Final Report
Value Engineering Study

Grand Avenue Bridge
CDOT Project No. FBR 0821-094(18158)

Prepared for
CDOT – Region 3

Dates of Study: November 4-8, 2013

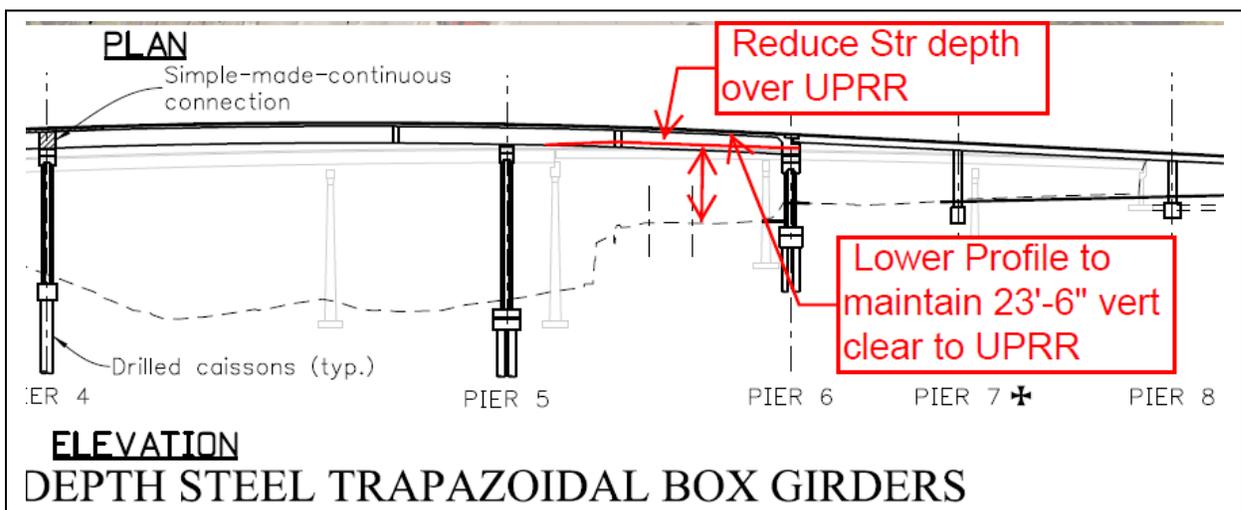
SH 82 Bridge structure depth could be made shallower over UPRR, by reducing the depth of the girders in the span over UPRR. The shallower structure depth would then accommodate lowering the SH 82 profile over the UPRR, resulting in cost reductions to the bridge and the south approach to the SH 82 Bridge.

Estimated potential cost savings: \$ 0.2 million

Proposal No.	VE Proposal Summary Recommended Action: Incorporate into Design	<u>Review Board Response</u>
1	SH82 Bridge structure depth is shallower over UPRR Savings potential: \$200,000	<p><u>Accept with conditions</u> – Evaluate how lowered vertical profile would work for design standards and accommodating clearance at alley downtown. If that is acceptable then: Evaluate vertical webs for easier fabrication. If both are favorable then accept.</p> <ul style="list-style-type: none"> • Opportunity to make the transition work better (visual) • Challenge for fabrication • Staff bridge policy requires a minimum of a 5 foot girder depth over the RR to provide for inspection access and the design will meet the requirement. Staff Bridge would allow inspection access form the top for a short distance of girder depth of 4’-6” and the team concluded this will be impractical for safety and durability concerns. • The boxes will have vertical webs and not utilize a trapezoidal shape for ease of fabrication and reduction costs. • The profile grade still needs to be at a certain height over the alley, minimizing how much profile grade could be lowered. • The aesthetics of introduction one varying depth span between two constant depth units of different structure to be further considered.

Proposed Configuration keeping N. River Street open during construction (NTS)

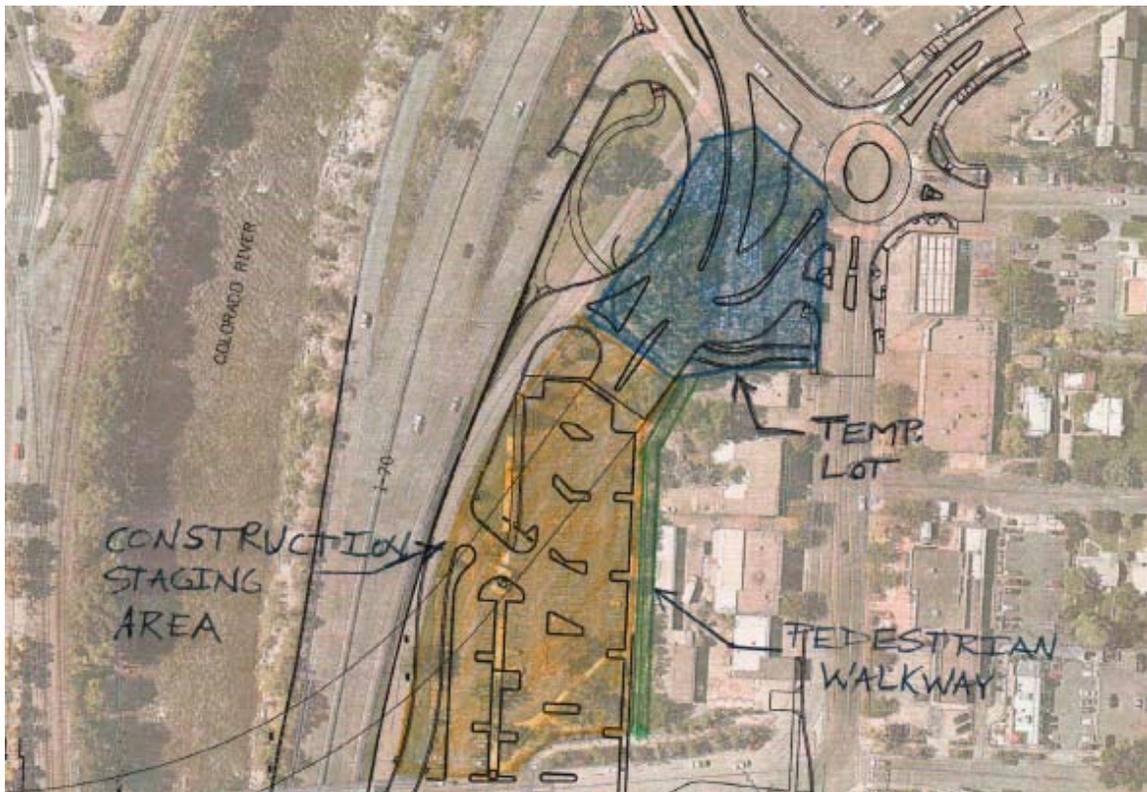
Provide an area for construction activities and staging in a convenient location. This area is located in the area of a portion of the bridge.

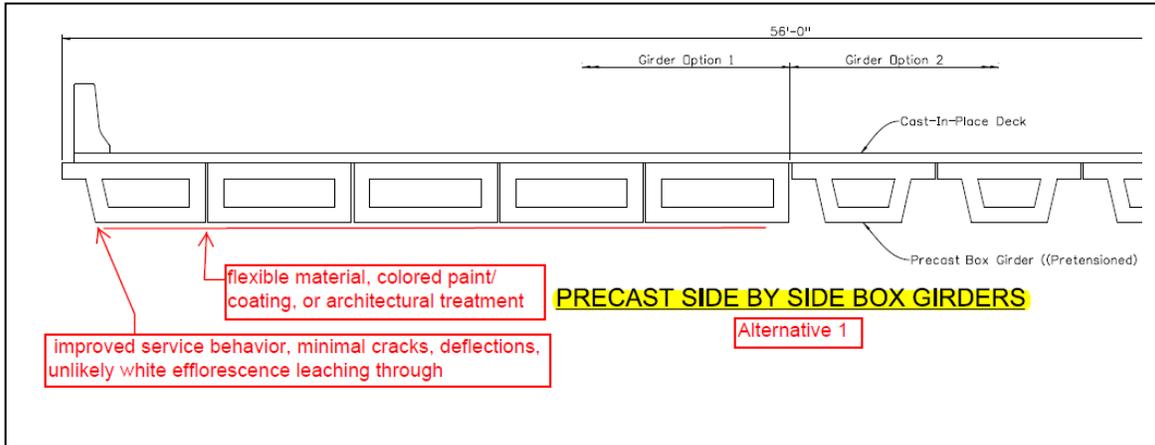
SH 82 bridge Downtown Unit could achieve increased value through cost reductions and through construction duration reductions, by considering precast concrete and precast pretensioned concrete structure components for the downtown unit. Pretensioned concrete girders are less costly, reduce construction duration, and provide better serviceability over the life of the structure. Precast concrete columns, pier caps, and abutment caps reduce construction duration.

SH 82 Bridge Downtown Unit superstructure using precast pretensioned concrete girders in side-by-side configuration with cast-in-place reinforced concrete composite topping slab structure depth is a more efficient structure type. Using precast pretensioned concrete box girders, a 2'-6" girder depth would provide adequate strength and provide stresses complying with the service limit states for 75' span length. A nominal 5.5" thick reinforced concrete slab cast-in-place on the girders achieves composite behavior.

Proposal No.	VE Proposal Summary Recommended Action: Incorporate into Design	<u>Review Board Response</u>
14 and 54	SH 82 Bridge downtown unit use precast pretensioned components Savings potential: \$200,000	<u>Decline</u> – Aesthetics vs. construction duration tradeoff. Side by side boxes were considered for the advantages it has over reinforced concrete as stated in the VE proposal. However, the design team had aesthetic concerns over variable girder cambers, not just the gaps between girders. This will be a high profile area where a smooth CIP soffit is preferred. Drop caps required for the precast boxes will also create more visual mass and possibly cut into minimum head room at pier 8. Reinforced concrete, if designed and detailed correctly will meet the 75 year service life required by AASHTO. Efflorescence seems more of a concern for a bare concrete riding surface, but this bridge will have a high quality polyester concrete wearing course.

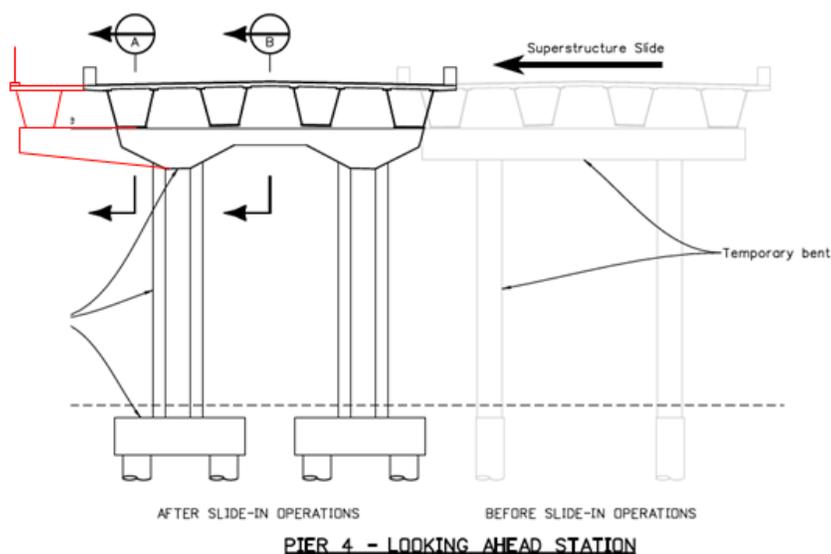
Instead of installing a completely new pedestrian bridge, attach a portion of the new pedestrian bridge to the new Grand Avenue Bridge (“GAB”) until pier 4, then split it off and land it at the same point the current pedestrian bridge lands.

The idea was to eliminate the new pedestrian bridge in the proposed location, make use of the substructure for the new GAB, and narrow the proposed ped bridge from 18’-0” to 13’-0” (12’-0” multi-modal path plus the 1’-0” architectural fence/footing currently shown on the proposed ped bridge drawing). It made sense to attach the ped bridge to the main bridge between the south touchdown point and pier 4 and then split it off and land it at the current ped bridge touchdown on the north side. While investigating this proposal some fatal flaws were discovered:

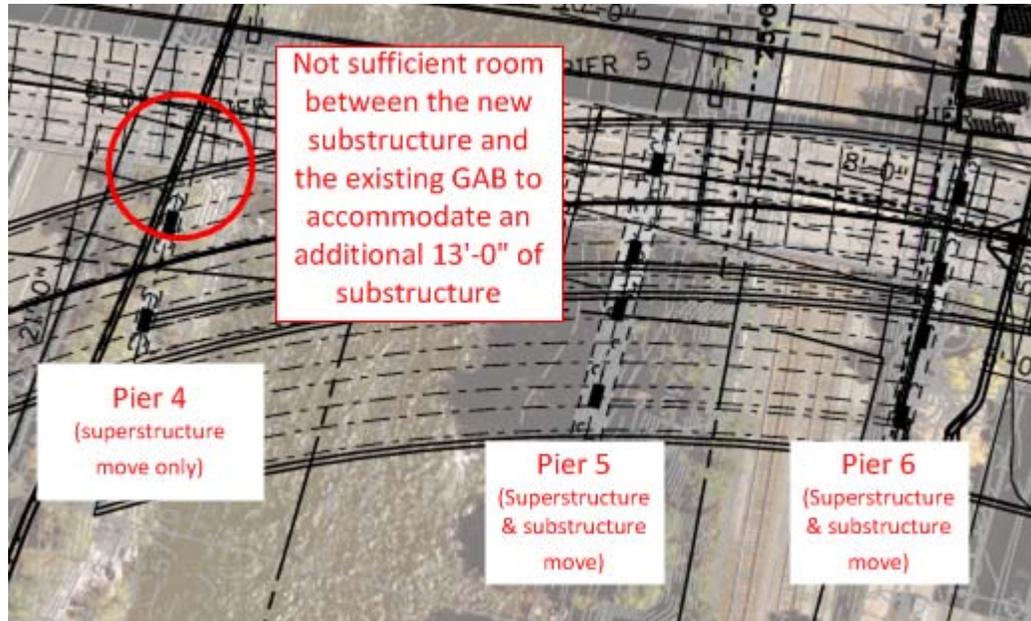
- The current plans show constructing the substructure at pier 4 in place and only moving the superstructure. At piers 5 and 6 both the substructure and superstructure are planned to be moved into place. *Attaching the pedestrian bridge to the east side of the GAB bridge will require the substructure at pier 4 to be constructed off alignment and then moved into place with the superstructure because there is not sufficient room between the east side of pier 4's substructure and the existing GAB to allow pier 4's substructure to be extended an additional 13'-0" to the east and built in place* (see picture below).

Figure 1
Eliminated Items (NTS)

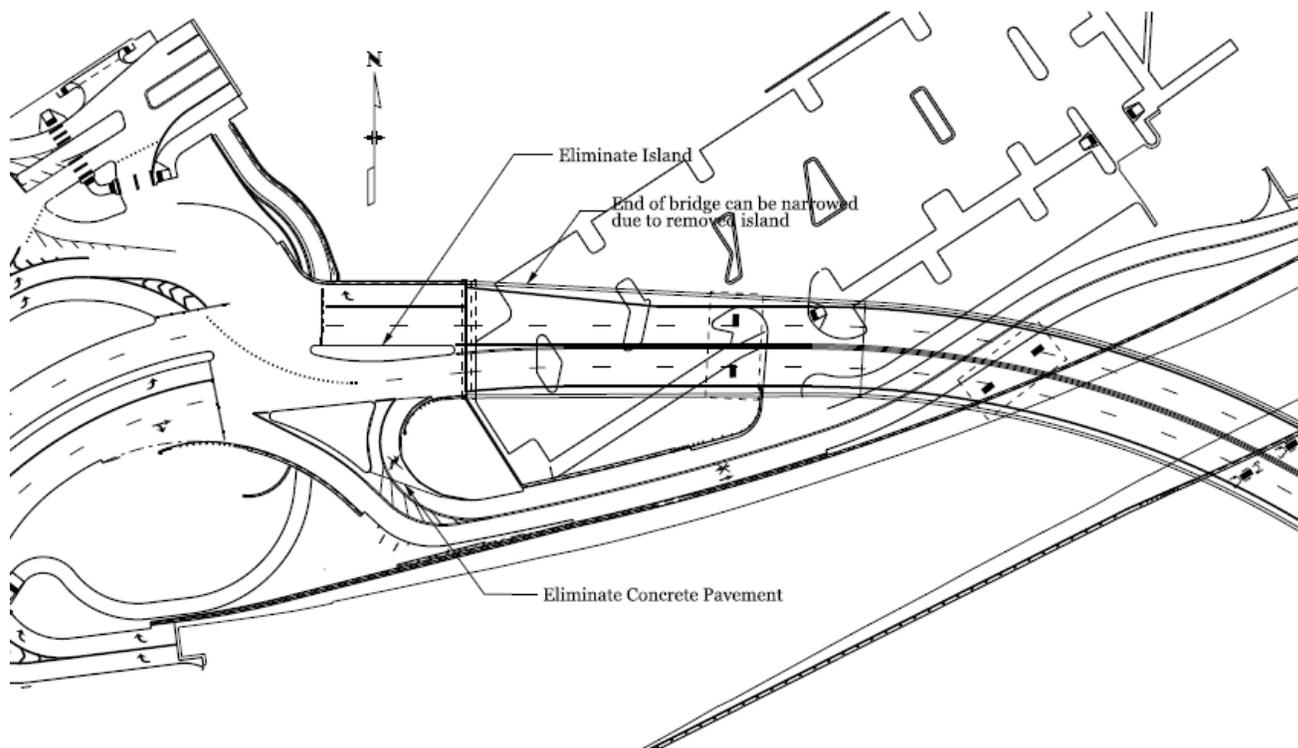
Note: See Figure 1 for eliminated items that lead to cost savings.

Concept Sheet 1 - Drilled Shaft Wall Plan View (Option 1)

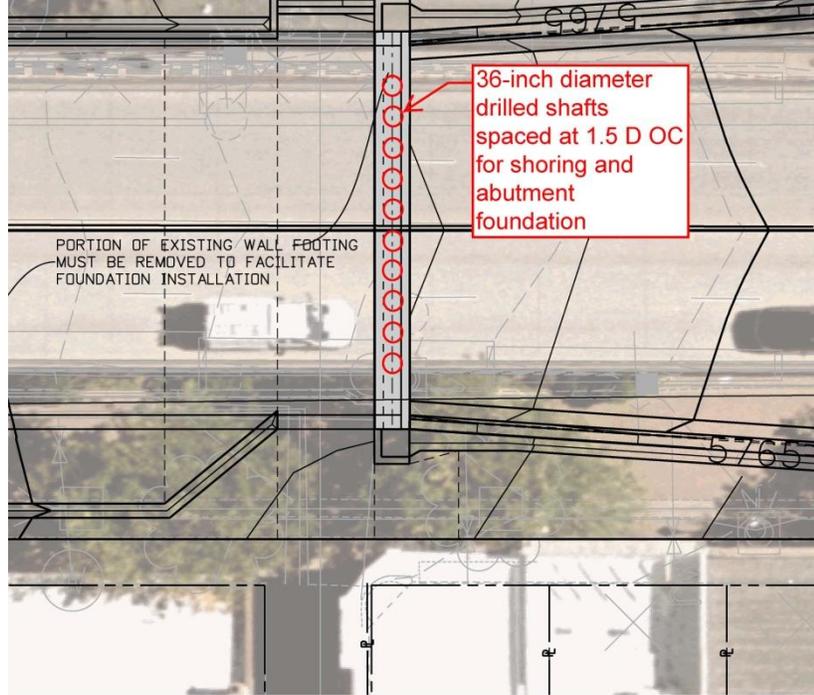
The current abutment construction plan consists of a temporary shoring box that is advanced into the subgrade during night work activities. The temporary shoring box installation will require closure of two lanes for 1 to 2 nights. The shoring box will accommodate construction of the spread footings and abutment face while maintaining traffic. A concrete or steel plate will be placed over the box during non-work periods for uninterrupted traffic flow.

Option 3 – Install at spread footing within the current wall mass during night closures. Once Grand Avenue is closed, remove most fill but leave the abutment below the footing at a temporary stable slope configuration. Once the bridge is completed, remove the fill in front of abutment and place a soil nail wall under the spread footing.

Proposal No.	VE Proposal Summary Recommended Action: Incorporate into Design	<u>Review Board Response</u>
30	Use “top-down” abutment construction at south end of Grand Avenue Bridge Savings potential: \$40,000	<u>Reclassify as Design Consideration</u> – Defer for additional evaluation as the proposal may have some merit once final caisson and spread footing design parameters are better understood. A CIP facing is desired, and the proposed wall system may not easily accommodate that.
31	Move the south abutment of the Grand Avenue Bridge to the location of Pier 7 Savings potential: \$790,000	<u>Decline</u> – Location of the abutment was heavily influenced by the CSS process and has been the subject of much discussion. Wrapping wall downtown not compatible. Proposed abutment would be a big wall, aesthetically unfavorable. Additional historic property impacts possible. Removes open area under bridge.

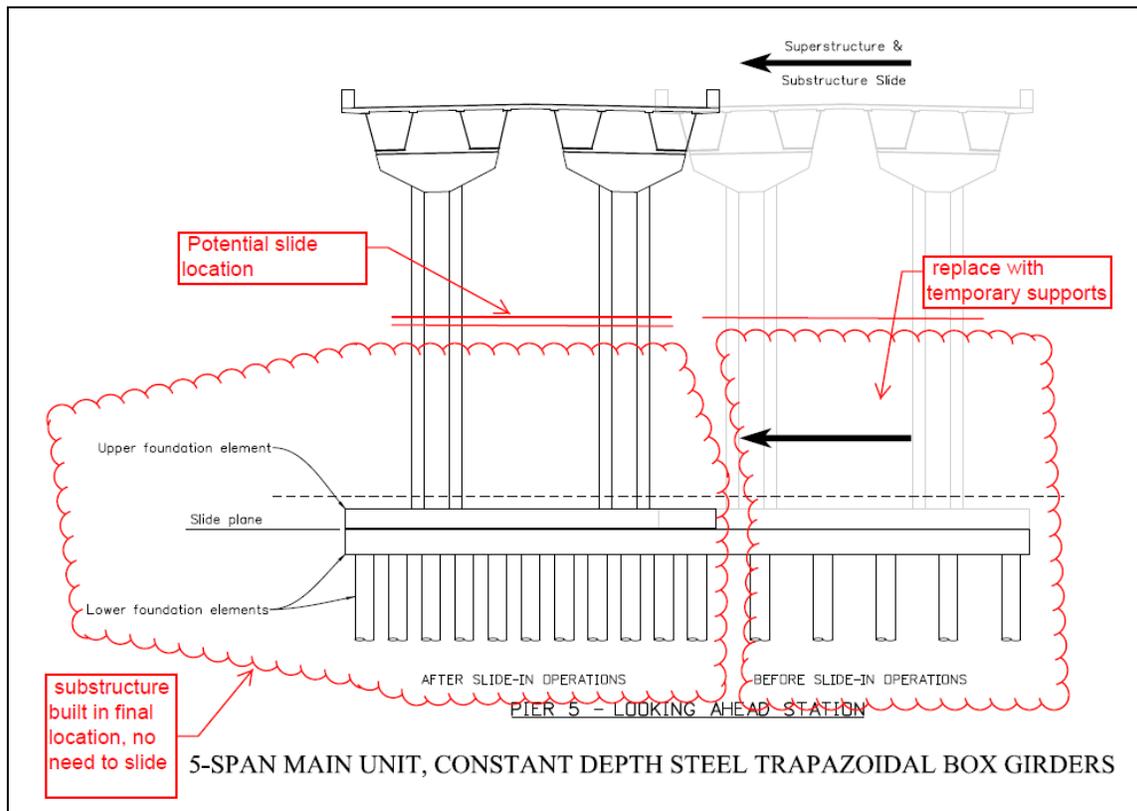
SH 82 Bridge replacement preliminary bridge plans show Pier 5 and Pier 6 being moved with the superstructure; the slide interface is located at the foundation level. Another potential solution is to adjust the slide interface location higher.

SH 82 Bridge replacement uses Accelerated Bridge Construction (ABC) to move two spans laterally during a closure period, minimizing the duration of the closure period. Preliminary bridge plans show Pier 5 and Pier 6 being moved with the superstructure; the slide interface is located at the foundation level. This concept provides a stable surface for the slide, using the upper foundation sliding on the lower foundation footing.

Figure 1: SH 82 Bridge Width Reduction at North Flare

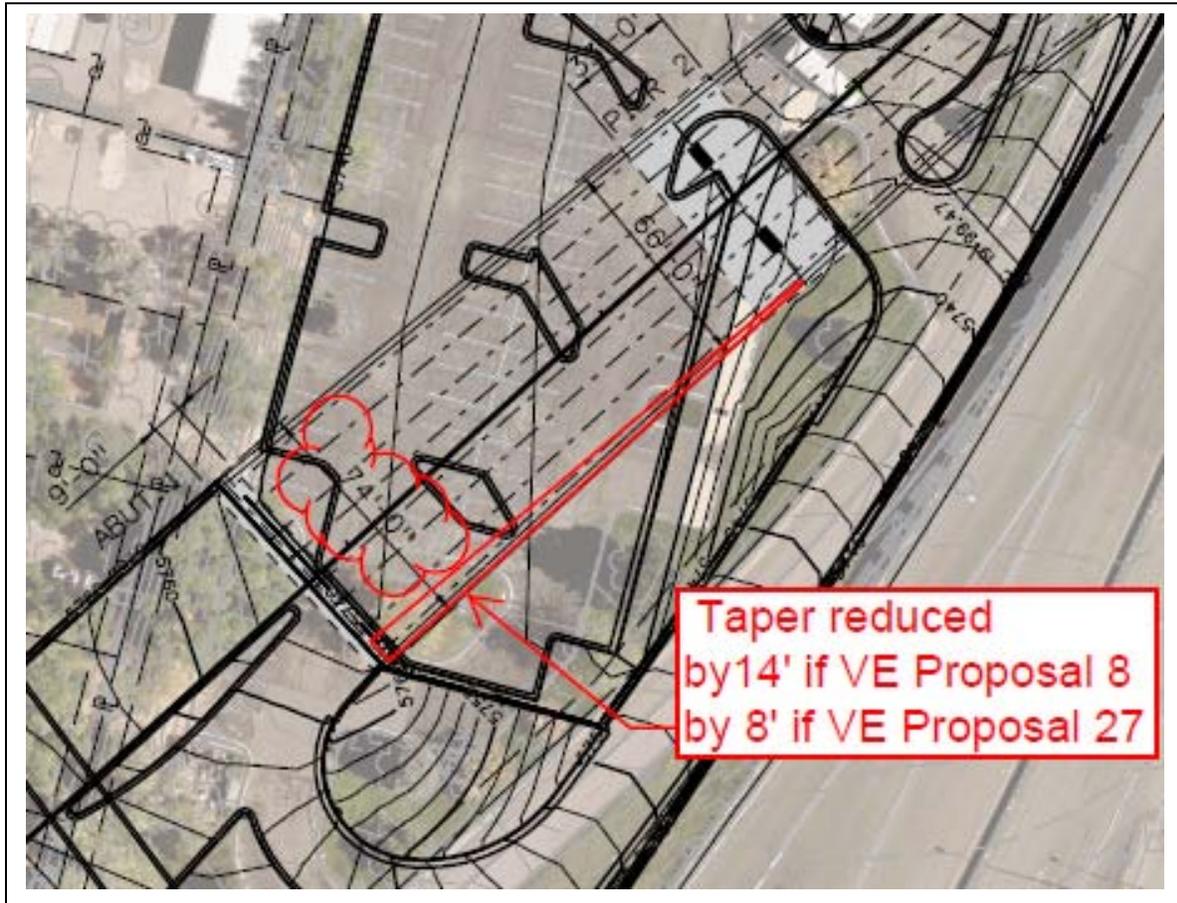
SH 82 Bridge width could be reduced at the north flare to achieve cost reductions. A narrower SH 82 Bridge superstructure would be more efficient and less costly, thereby increasing value. Abutment 1 and Pier 2 quantities are reduced. Removing the width flare eliminates the need for extra plow trips to remove snow in the flared section.

2. If the westbound River Street loop ramp to southbound SH 82 were eliminated, as described in Value Engineering Proposal No. 27, the median in the center of SH 82 just northeast of the bridge could be eliminated, and the taper for SH 82 that extends from the center median onto the SH 82 bridge would not be needed. The elimination of the taper onto the SH 82 bridge would reduce the width taper by 8' at the median to 0' beyond Pier 2, over a length of 248'. The SH 82 bridge area would be reduced by 992 square feet.

3. If the pool parking space total is reduced to a zero-net-gain or 5-space-gain, instead of the preliminary layout with a 12 parking space gain, as described in Value Engineering Proposal No. 18, the SH 82 bridge Abutment 1 could be moved 20' closer to Pier 2. The result would be a span length reduction of 20' at the beginning of span 1, where the SH 82 bridge is 74 wide. The SH 82 bridge area would be reduced by 1,480 square feet.
